SAFETY RECALL NOTICE

2013 – 2016 Cannondale CAADX Cyclocross Bicycles

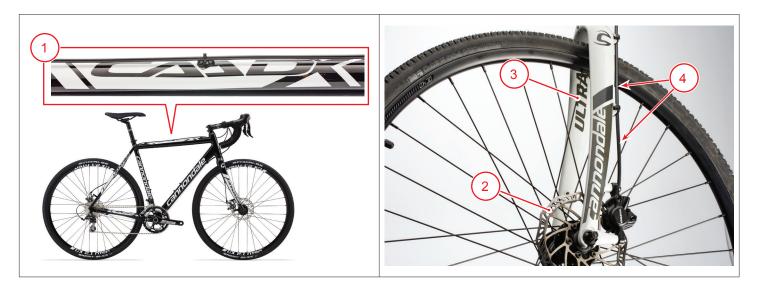
The fork can fracture, which can allow the wheel to detach from the bicycle during use, posing a fall hazard.

- 1. The bicycle has a prominent "CAADX" marking on the top tube or other location.
- 2. The bicycle has disc brakes.
- 3. The inside of each fork leg has a large "ULTRAX" marking.
- 4. The cable connected to the front disc brake is completely outside the fork blade.(Later models, not subject to recall, have the cable connected to the front disc brake routed internally, inside the structure of the fork blade.)

Consumers should stop using the recalled bicycle and contact the nearest Cannondale dealer for a free repair. Cannondale dealers will replace, free of cost, the bicycle's fork with a full carbon fiber replacement fork.
